Submission to the
Environmental Impact Statement
Albury 2 Illabo
Inland Rail Project

David Carter

- Myself and as
- Chair, NSW Farmers Association Illabo Branch

6.3.5 LEVEL CROSSINGS – SHORT STACKING ASSESSMENT

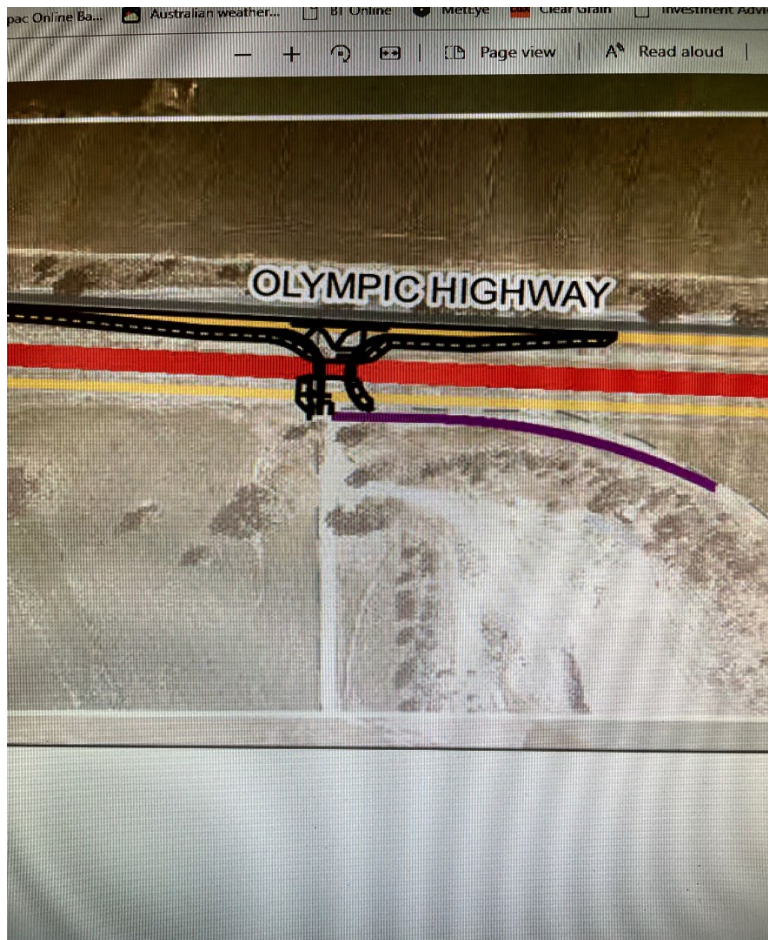
- Sladen St, LX625 – ARTC is continuing to consult with TfNSW, however
- Private Crossing, LX605 – no consultation with the owners but told what they are getting

The assessment that crossing LX 605 also needs concrete barriers as per picture when the proposed alterations will

- Severely impact on the usage of the crossing by the occupiers
- Create a traffic hazard on a major state highway, the Olympic Highway.

QUESTION: why does one crossing get a different treatment than the other and won't these concrete barriers present a traffic hazard on the Olympic Highway?
